SITE PLAN

BLOOMINGTON
COLLISION &
REPAIR

8925 LYNDAL AVE. SOUTH
BLOOMINGTON, MN 55420

PL202200253
PL2022-253

1ST FLOOR PLAN
A1.10

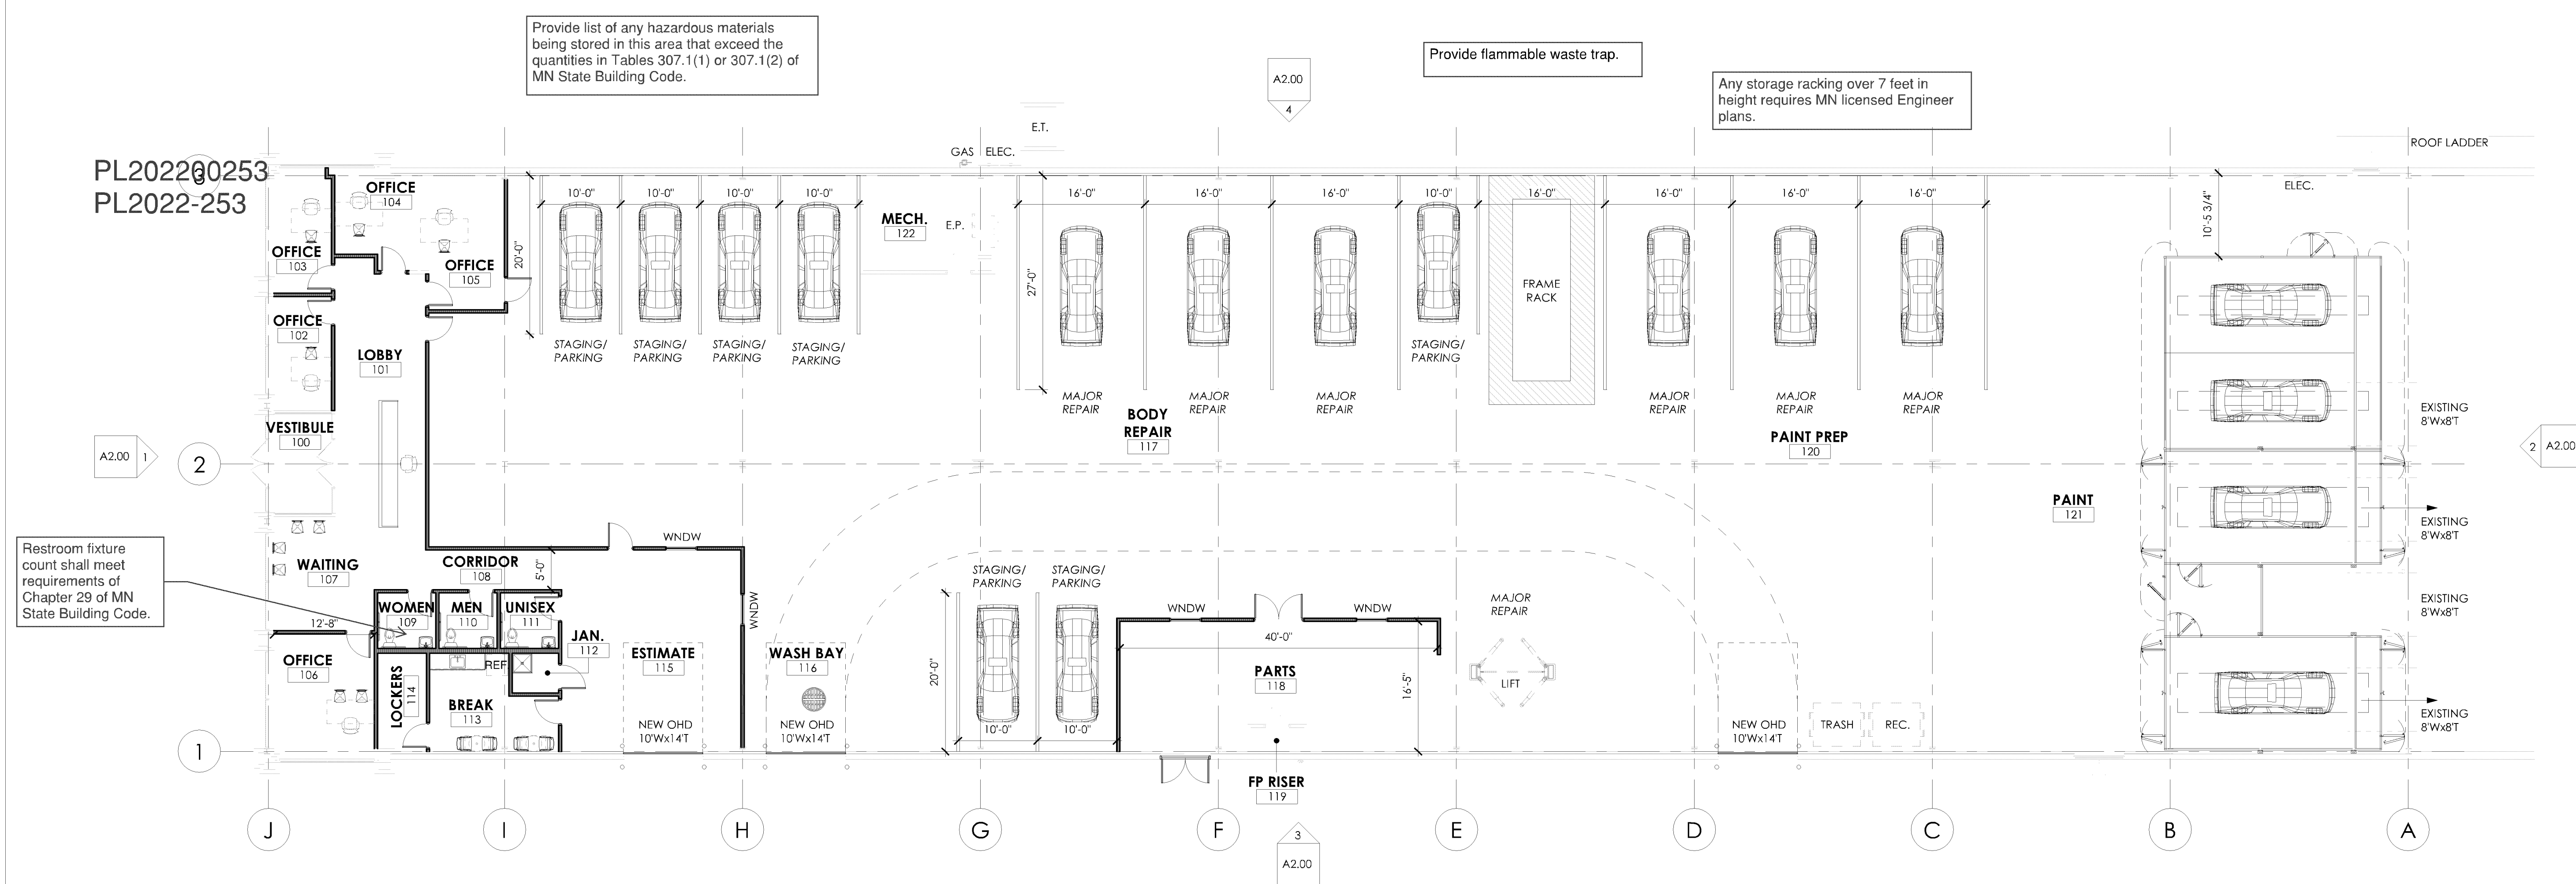
Restroom fixture
count shall meet
requirements of
Chapter 29 of MN
State Building Code.

- Must meet 2020 MN
State Building Code
- Building plans must
be signed by a MN
licensed architect.
- Must meet 2020 MN
Accessibility Code.
- SAC review by MET
council will be required.
- Provide a detailed code
analysis with the plans.
